WCE No. 13-1166
February 17, 2017

City of Spokane Valley
11707 E Sprague Avenue Suite 106
Spokane Valley WA 99206

Re: Painted Hills TIA – Addendum Letter

Exhibit 1310-7a

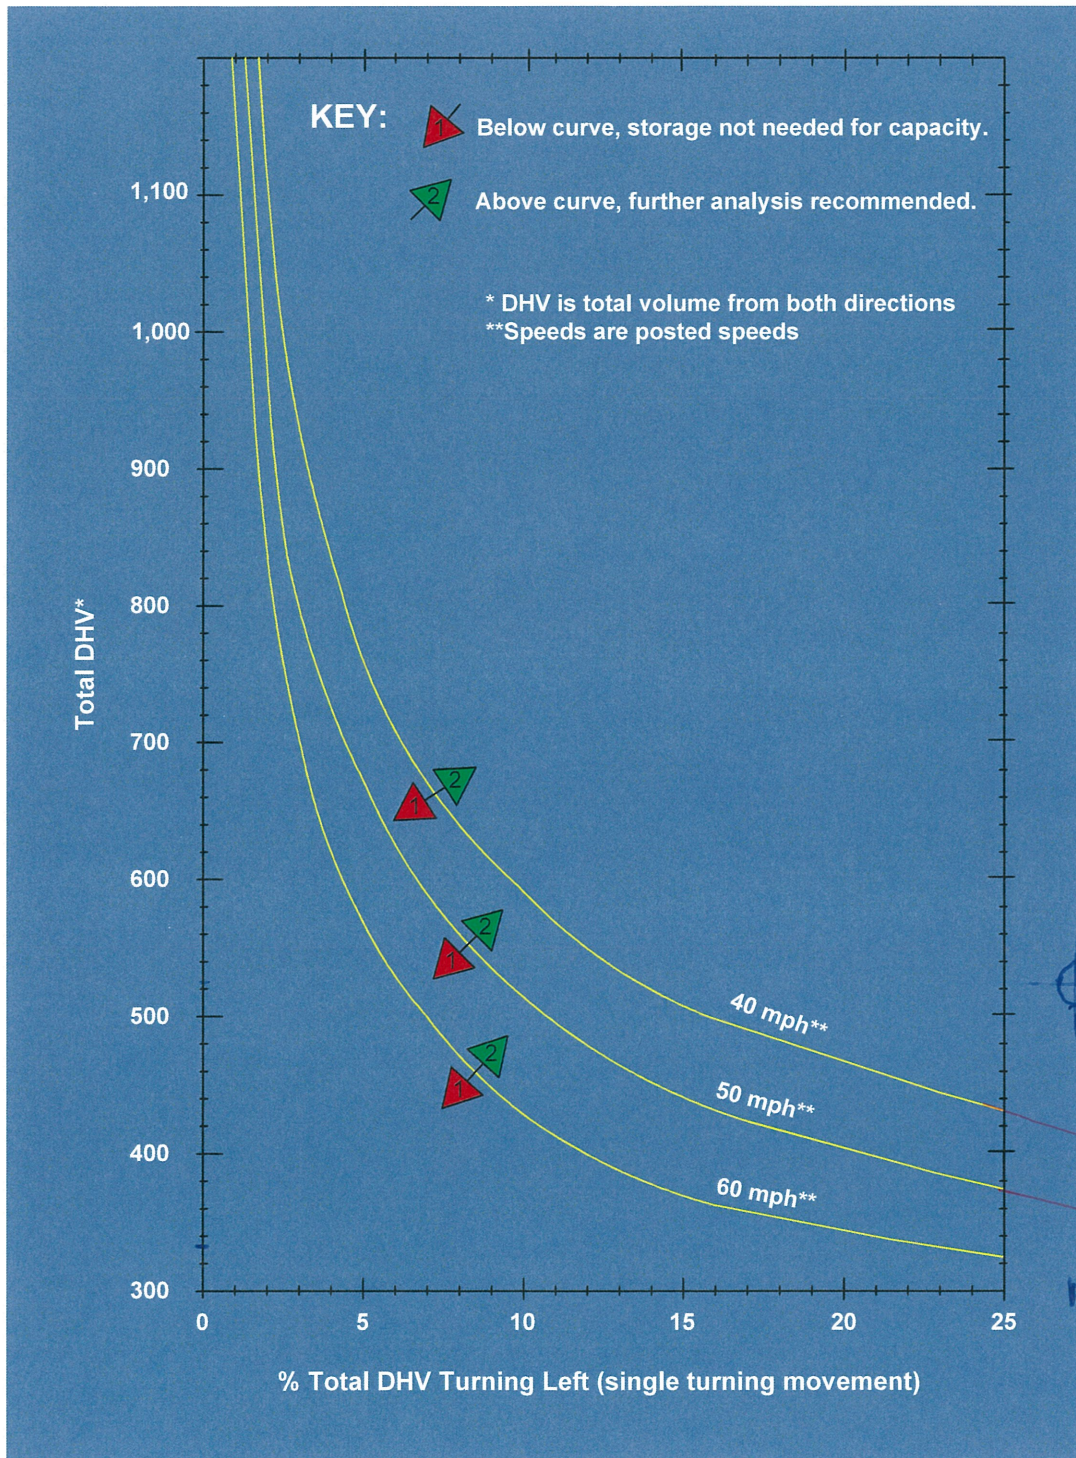
1. For the Southbound left turn lane warrant at the intersection of Dishman-Mica Road & Thorpe Road, the turn lane is warranted. A copy of the WSDOT Exhibit 1310-7a has been attached. On the attached the exhibit, the values have been plotted.

We request that the City of Spokane Valley make the turn lane a condition of the project.

Dishman-Mica & Thorpe Road

Year 2025
w/proj

SBL 139
DHV 522

% DHV Left
 $\frac{139}{522} = 27\%$
